Access Compliance Report Public Rights-of-Way (Curb Ramps)

Main Street: N/A		Cross Street: AVENDALE BLVD		Location:	NW
ADA ID: RPAT220125102240	Ramp Type: Type 4 - Parallel	Initial Pass/Fail: Fail	Overall Compliance: No	Severity Score:	2
Codes/Mitigation Info/Possible Solution			Field Measurements/Component Compliance

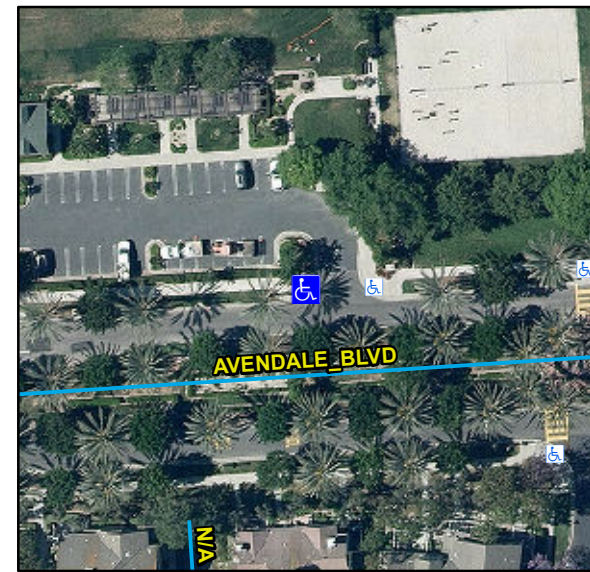
R204.3, R304.5.3, STD 1115

Compliance	Description	Data	Compliance	Description	Data
N/A	Ramp Length LT (in)	55	N/A	Ramp Length RT (in)	55
Yes	Ramp Width LT (in)	88	Yes	Ramp Width RT (in)	90
Yes	Ramp Run Slope LT (%)	0.8	Yes	Ramp Run Slope RT (%)	4.9
Yes	Ramp Cross Slope LT (%)	1.2	No	Ramp Cross Slope RT (%)	3
N/A	Landing Present	N/A	N/A	DWS Provided	N/A
N/A	Landing Length (in)	N/A	N/A	DWS Contrast	N/A
N/A	Landing Width (in)	N/A	N/A	DWS Length (in)	N/A
N/A	Landing Run Slope (%)	N/A	N/A	DWS Full Width	N/A
N/A	Landing Cross Slope (%)	N/A		DWS Offset Type	N/A
N/A	Landing Movement Obstructed?	N/A	N/A	DWS Offset Left (in)	N/A
	Landing Movement Type	N/A	N/A	DWS Offset Right (in)	N/A
N/A	Landing Shared	N/A			
N/A	Clear Space	N/A			
N/A	Clear Space To Crosswalk (in)	N/A			
N/A	Marked Crosswalk 1	No	N/A	Marked Crosswalk 2	N/A
	Crossing 1 Direction	SE		Crossing 2 Direction	N/A
N/A	Marked Crosswalk 1 Width (in)	N/A		Marked Crosswalk 2 Width (in)	N/A

Remove & Replace Entire Ramp.
